SP 2-219-003
SERVICE PROGRAM

Charge air cooler (CAC) pipe replacement.

This service program provides information regarding the replacement of the CAC pipe on certain 2016 model year Xpeditor vehicles equipped with ISX-G engines.

Figure 1

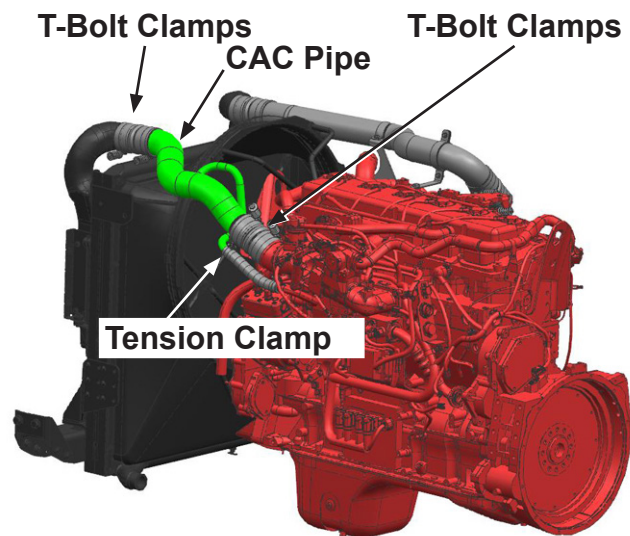
3. Remove and discard the CAC pipe by first loosening the T-Bolt clamps and then, using standard pliers, removing the tension clamp, and set aside for reinstallation (See Figure 1).
4. Install the new CAC pipe (A2190245-001) and tighten the T-Bolt clamps to 72 in-lb/6 ft-lb of torque. Reinstall the tension clamp (See Figure 1).
